HIVE – Russell Building: Preservation of Sources

HIVE - RUSSELL COMPARISON

MINOR MODIFICATION RENDERED ELEVATION OF PROJECT
SHOWING ALL PHASES

PHASE 1 - EAST BUILDING ELEVATIONS

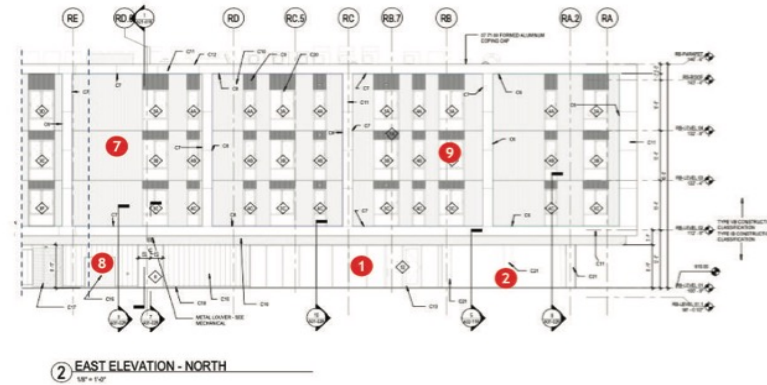
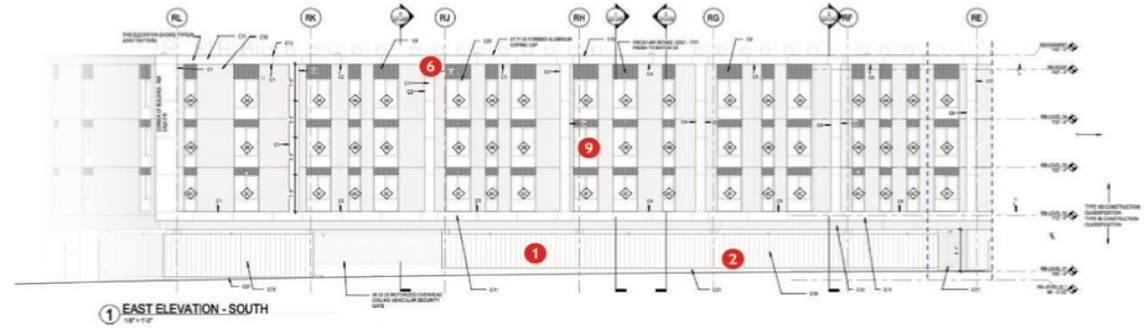
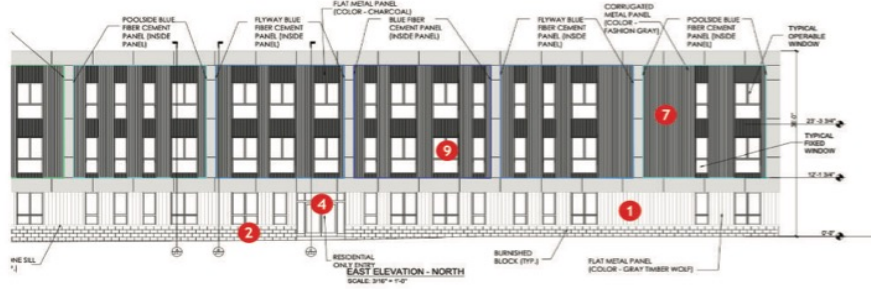
| | 1 | 2 | 3 | 4 | 5 | 6 | 7 | 8 | 9 |
|----------|--|---|---|---|--|---|---|--|---|
| ORIGINAL | 4 STORY BUILDING. FIRST FLOOR IS COVERED PARKING LOT | FLAT METAL PANELING WITH AN 8" +/- CMU BASE | EXCLUDING THE EAST ELEVATION, NO TRIM PIECE BETWEEN THE 1ST & 2ND FLOORS. THE COVERED PARKING AREA ACTED AS A TRANSITION BETWEEN THE TWO FLOORS AND HELPED FRAME OUT THE UPPER FLOORS | NO RESIDENTIAL ENTRANCE ON RUSSELL. ENTRANCE TO WATER & ELECTRIC ROOM WAS FLUSH WITH BUILDING ELEVATION | NO COVERED RESIDENTIAL ENTRANCE ON THE WEST ELEVATION FACING THE PARKING LOTS | RENDERING WERE NEVER UPDATED TO SHOW THE FINALIZED COLORS AND DID NOT SHOW THE COLORS ON THE TOP OF THE FACADE EXTRUSION | ORIGINAL PERMIT DRAWINGS SHOW FLAT METALS, CORRUGATED METAL PANELS, FIBER CEMENT PANELS & METAL TRIM FOR THE FACADE | BUILDING PROPOSED A ROLL UP DOOR TO HOLD DUMPSTERS | BUILDING PROPOSED FLOOR TO CEILING WINDOWS IN THE UNITS |

| | 1 | 2 | 3 | 4 | 5 | 6 | 7 | 8 | 9 |
|----------|--|---|---|---|--|---|---|--|---|
| NEW | 3 STORY BUILDING. NO MORE COVERED PARKING LOT | MIN. OF 2'-4" BURNISHED BLOCK WITH LIMESTONE SILL. THE SAME FLAT METAL PANELS FROM THE ORIGINAL DESIGN WILL BE USED ABOVE THE SILL. METAL PANELING TO GRADE WILL DETERIORATE DUE TO SALT APPLICATION. BURNISHED BLOCK TO BE LIGHT GRAY IN COLOR, TO MATCH THE OTHER COLORS OF THE BUILDING. STONE SILL WILL BE USED TO MATCH WINDOW SILLS | 5" FIBER CEMENT TRIM ON THE NORTH SOUTH & WEST. ELEVATIONS TO HELP RECREATE THE SEPARATION BETWEEN THE 1ST & 2ND FLOOR | THERE IS NOW A RESIDENTIAL ENTRANCE ON RUSSELL. BOTH SETS OF ENTRANCES ARE NOW RECESSED. | PROVIDED A CANOPY FOR THE RESIDENTIAL ENTRANCE. CANOPY COLOR TO MATCH THE BLUE COLOR FROM THE EAST ELEVATION | THE RENDERINGS WERE RECREATED BY A DIFFERENT ARCHITECTURAL FIRM. COLORS NOW MATCH WITH WHAT IS SHOWN ON THE ORIGINAL PERMIT SET OF DRAWINGS | NEW DESIGN WILL UTILIZE THE SAME MATERIALS AND COLORS (SEE CHART) | TRASH DUMPSTER IS NOW IN ITS OWN ENCLOSURE ON THE TRIANGULAR PARCEL, NEXT TO THE PARKING LOT | WINDOWS ARE NOW 7'-6" IN HEIGHT |

PHASE 1 - WEST BUILDING ELEVATIONS

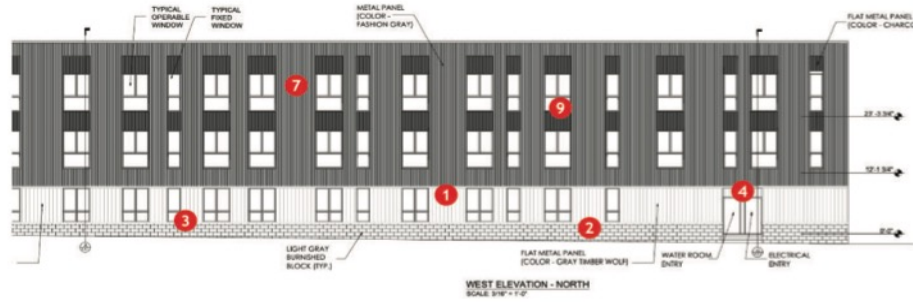
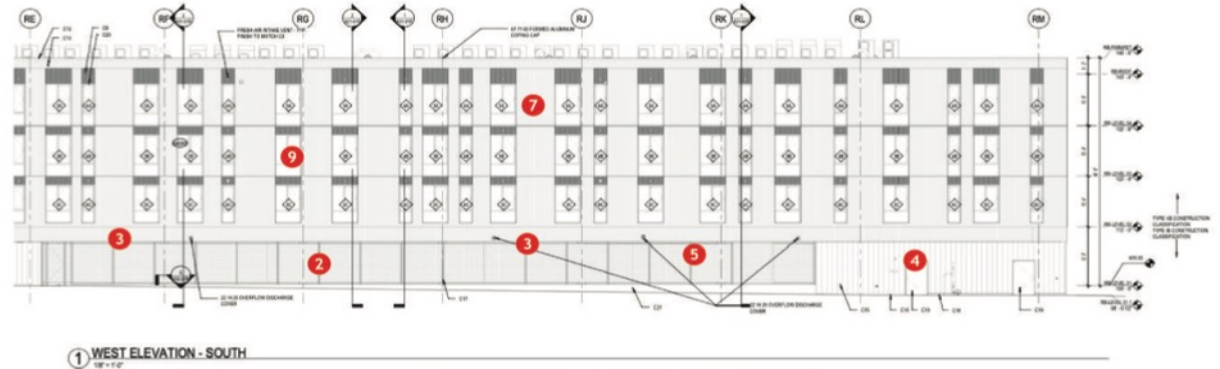
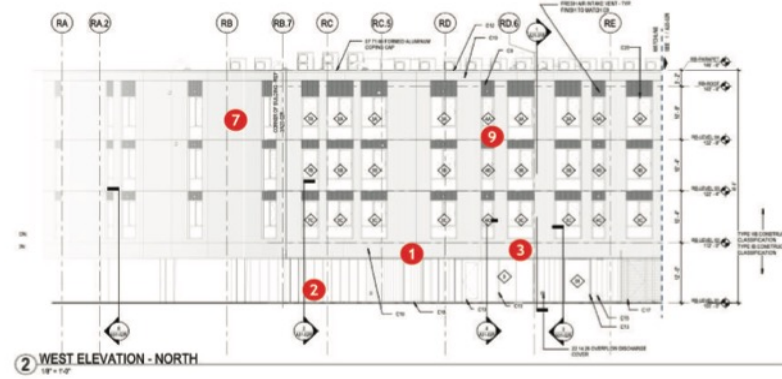
| | 1 | 2 | 3 | 4 | 5 | 6 | 7 | 8 | 9 |
|----------|--|---|---|--|--|---|---|--|---|
| ORIGINAL | 4 STORY BUILDING. FIRST FLOOR IS COVERED PARKING LOT | FLAT METAL PANELING WITH AN 8" +/- CMU BASE | EXCLUDING THE EAST ELEVATION, NO TRIM PIECE BETWEEN THE 1ST & 2ND FLOORS. THE COVERED PARKING AREA ACTED AS A TRANSITION BETWEEN THE TWO FLOORS AND HELPED FRAME OUT THE UPPER FLOORS | NO RESIDENTIAL ENTRANCE ON RUSSEL. ENTRANCE TO WATER & ELECTRIC ROOM WAS FLUSH WITH BUILDING ELEVATION | NO COVERED RESIDENTIAL ENTRANCE ON THE WEST ELEVATION FACING THE PARKING LOTS | RENDERING WERE NEVER UPDATED TO SHOW THE FINALIZED COLORS AND DID NOT SHOW THE COLORS ON THE TOP OF THE FACADE EXTRUSION | ORIGINAL PERMIT DRAWINGS SHOW FLAT METALS, CORRUGATED METAL PANELS, FIBER CEMENT PANELS & METAL TRIM FOR THE FACADE | BUILDING PROPOSED A ROLL UP DOOR TO HOLD DUMPSTERS | BUILDING PROPOSED FLOOR TO CEILING WINDOWS IN THE UNITS |

| | 1 | 2 | 3 | 4 | 5 | 6 | 7 | 8 | 9 |
|----------|--|---|---|--|--|---|---|--|---|
| NEW | 3 STORY BUILDING. NO MORE COVERED PARKING LOT | MIN. OF 2'-4" BURNISHED BLOCK WITH LIMESTONE SILL. THE SAME FLAT METAL PANELS FROM THE ORIGINAL DESIGN WILL BE USED ABOVE THE SILL. METAL PANELING TO GRADE WILL DETERIORATE DUE TO SALT APPLICATION. BURNISHED BLOCK TO BE LIGHT GRAY IN COLOR, TO MATCH THE OTHER COLORS OF THE BUILDING. STONE SILL WILL BE USED TO MATCH WINDOW SILLS | 5" FIBER CEMENT TRIM ON THE NORTH SOUTH & WEST, ELEVATIONS TO HELP RECREATE THE SEPARATION BETWEEN THE 1ST & 2ND FLOOR | THERE IS NOW A RESIDENTIAL ENTRANCE ON RUSSELL. BOTH SETS OF ENTRANCES ARE NOW RECESSED. | PROVIDED A CANOPY FOR THE RESIDENTIAL ENTRANCE. CANOPY COLOR TO MATCH THE BLUE COLOR FROM THE EAST ELEVATION | THE RENDERINGS WERE RECREATED BY A DIFFERENT ARCHITECTURAL FIRM. COLORS NOW MATCH WITH WHAT IS SHOWN ON THE ORIGINAL PERMIT SET OF DRAWINGS | NEW DESIGN WILL UTILIZE THE SAME MATERIALS AND COLORS (SEE CHART) | TRASH DUMPSTER IS NOW IN ITS OWN ENCLOSURE ON THE TRIANGULAR PARCEL, NEXT TO THE PARKING LOT | WINDOWS ARE NOW 7'-6" IN HEIGHT |

PHASE 1 - NORTH & SOUTH BUILDING ELEVATIONS

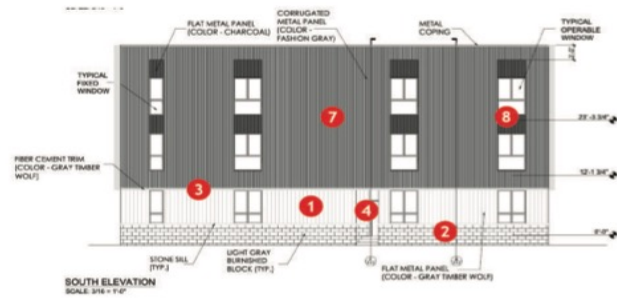
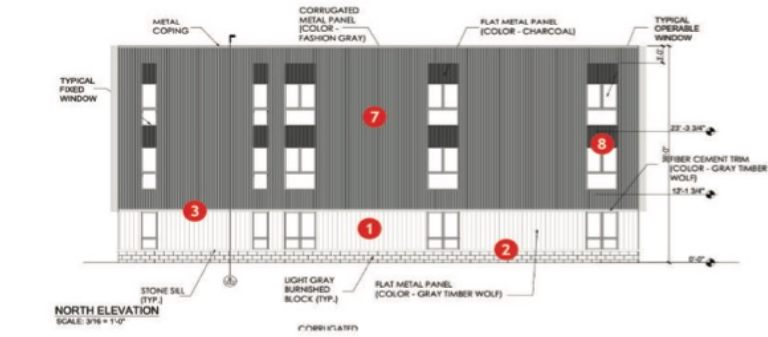
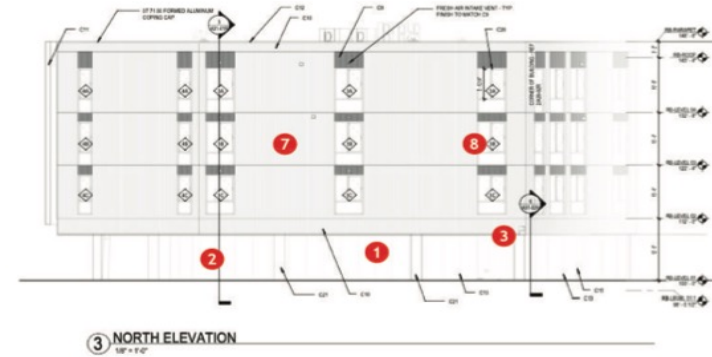
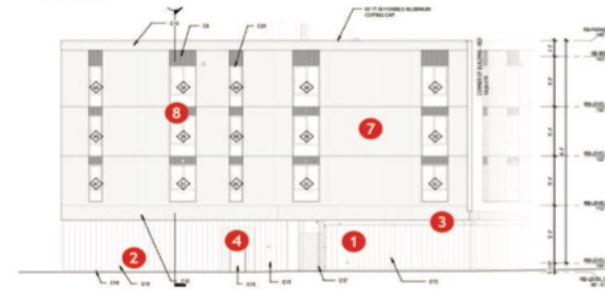
| | ① | ② | ③ | ④ | ⑤ | ⑥ | ⑦ | ⑧ | ⑨ |
|----------|--|-----------------------------------|---|---|--|---|---|--|---|
| ORIGINAL | 4 STORY BUILDING. FIRST FLOOR IS COVERED PARKING LOT | FLAT METAL PANELING WITH AN 8\"/> | EXCLUDING THE EAST ELEVATION, NO TRIM PIECE BETWEEN THE 1ST & 2ND FLOORS. THE COVERED PARKING AREA ACTED AS A TRANSITION BETWEEN THE TWO FLOORS AND HELPED FRAME OUT THE UPPER FLOORS | NO RESIDENTIAL ENTRANCE ON RUSSELL. ENTRANCE TO WATER & ELECTRIC ROOM WAS FLUSH WITH BUILDING ELEVATION | NO COVERED RESIDENTIAL ENTRANCE ON THE WEST ELEVATION FACING THE PARKING LOTS | RENDERING WERE NEVER UPDATED TO SHOW THE FINALIZED COLORS AND DID NOT SHOW THE COLORS ON THE TOP OF THE FACADE EXTRUSION | ORIGINAL PERMIT DRAWINGS SHOW FLAT METALS, CORRUGATED METAL PANELS, FIBER CEMENT PANELS & METAL TRIM FOR THE FACADE | BUILDING PROPOSED A ROLL UP DOOR TO HOLD DUMPSTERS | BUILDING PROPOSED FLOOR TO CEILING WINDOWS IN THE UNITS |

| | ① | ② | ③ | ④ | ⑤ | ⑥ | ⑦ | ⑧ | ⑨ |
|----------|--|-----------------------------------|---|---|--|---|---|--|---|
| NEW | 3 STORY BUILDING. NO MORE COVERED PARKING LOT | MIN. OF 2'-4\"/> | 5\"/> | THERE IS NOW A RESIDENTIAL ENTRANCE ON RUSSELL. BOTH SETS OF ENTRANCES ARE NOW RECESSED. | PROVIDED A CANOPY FOR THE RESIDENTIAL ENTRANCE. CANOPY COLOR TO MATCH THE BLUE COLOR FROM THE EAST ELEVATION | THE RENDERINGS WERE RECREATED BY A DIFFERENT ARCHITECTURAL FIRM. COLORS NOW MATCH WITH WHAT IS SHOWN ON THE ORIGINAL PERMIT SET OF DRAWINGS | NEW DESIGN WILL UTILIZE THE SAME MATERIALS AND COLORS (SEE CHART) | TRASH DUMPSTER IS NOW IN ITS OWN ENCLOSURE ON THE TRIANGULAR PARCEL, NEXT TO THE PARKING LOT | WINDOWS ARE NOW 7'-6\"/> |
